# SANDY CITY COMMUNITY DEVELOPMENT

# **MEMORANDUM**

Sandy Towers Sign Theme

SIGN-05-19-5652

Exhibit #2 – Sign Renderings

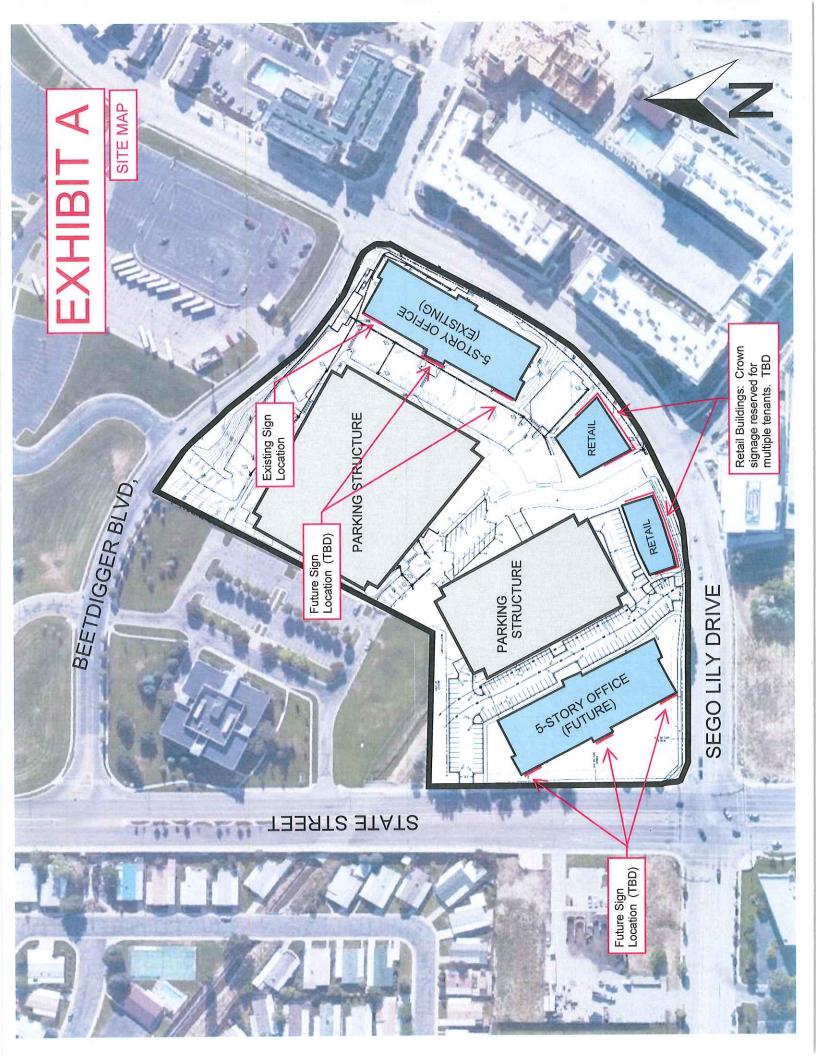
The applicant is proposing to install three wall signs on one facade of the two 5-story office buildings. Staff reviewed the number of wall signs on office towers in the Cairns District and found that the most signs attached to one façade is two (See Exhibit #3 – Office Tower Signs). Three signs on one façade would be more than what has been approved on office buildings throughout the Cairns District. However, some of the office buildings have three separate signs on the building, though these signs are on different facades.

Staff is concerned with the 100-500 square foot range that is being proposed by the applicant. Staff feels that three signs on one façade, with a maximum square footage of 500 square feet (1,500 square feet total), is excessive. The recent office tower sign themes approved by the Planning Commission are presented in a spreadsheet below. The largest wall signs approved in a sign theme have an average square footage of 334 square feet. The Jordan Commons Office Tower was the largest wall sign approved at 870 square feet, but this is a single wall sign and is an outlier in the data set. The MACU Office Building is larger due to the fact that there is only one sign on the east and west facades. Staff feels that capping the allowable wall signage at 300 square feet for an individual sign is compatible with the surrounding office buildings.

Staff recommends that the Planning Commission approve the proposed sign theme for Sandy Towers located at 99 East Sego Lily Drive, 111 East Sego Lily Drive, and 9985 South State Street to allow the installation of the proposed wall signs, with a maximum allowable square footage for the wall signs to be at 300 square feet for each sign, with a maximum of two signs per façade, subject to the following findings and conditions:
